**Permission sought for Residential Development at
Lucan Newlands Road / Esker Hill, Lucan, Co. Dublin,
for Nacul Developments Ltd.**

ADDITIONAL INFORMATION

REF. SD22A/0390

Figure 1: Site Layout Plan Submitted at Initial Planning Stage (prepared by CSA)

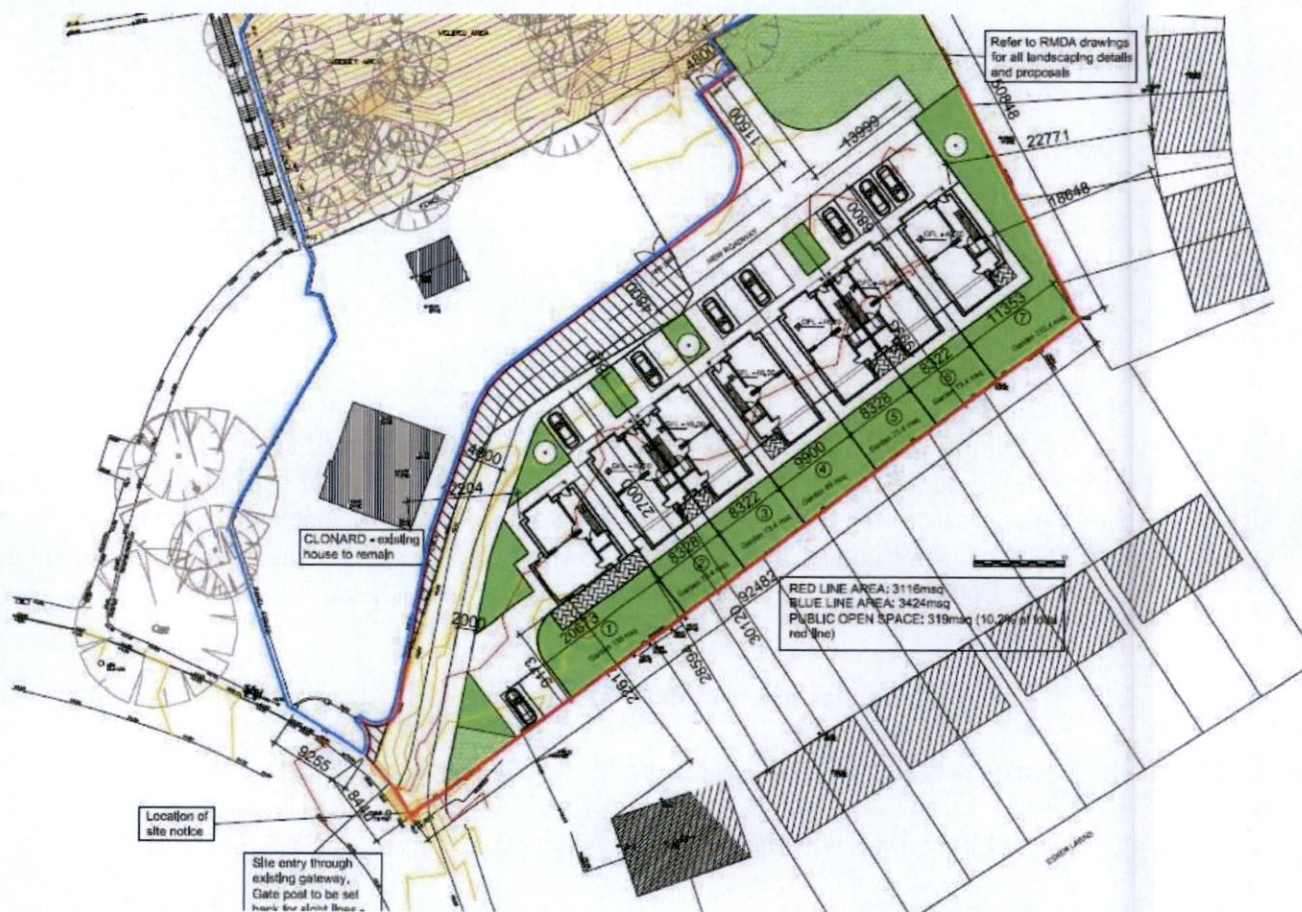
The Applicant is requested to provide revised Site Layout, Plan, Sectional, Elevational and Contiguous Elevational drawings of the proposed development, which demonstrate the following revisions:

- (i) *Re-site proposed House no. 7 to increase the separation distance between this dwelling and existing houses to the east.*

Crean Salley Architects (CSA) have prepared the submitted drawing no. 85675-RFI-004 which illustrates that the proposed house no. 7 and its separation distances between itself, and the existing housing located to the eastern boundary. As previously submitted at planning stage (figure 1 below), proposed house no. 7 was at a separating distance between c. 18.6 – 22.7 metres away from the existing houses to the east. The submitted revised site layout plan (drawing no. 85675-RFI-004) of the proposed development illustrates that the separation distance between proposed house no. 7 and the neighbouring houses to the east has been increased to c. 20.1 – 24.2 meters. The purpose being that house no. 7 is pulled back from the neighbouring boundary to the east with the current side gable of the proposed dwelling no. 7 being a further c. 2 meters away from the rear of its nearest neighbour. This is due to a revision whereby the widths of the proposed houses have been reduced by 125mm, and the separation distance between the proposed houses being reduced from 2,500mm to 2,350mm. This allows houses 2 to 7 to migrate towards house 1, giving greater separation of 1,475mm laterally to the houses in Esker Lawns to the east. In addition, CSA have prepared the enclosed drawing no. 85675-RFI-030 that details the proposed north elevations of the proposed development and proposed house no.7 and its separation distance between the existing neighbouring Esker Lawns housing to the east – please refer to same.
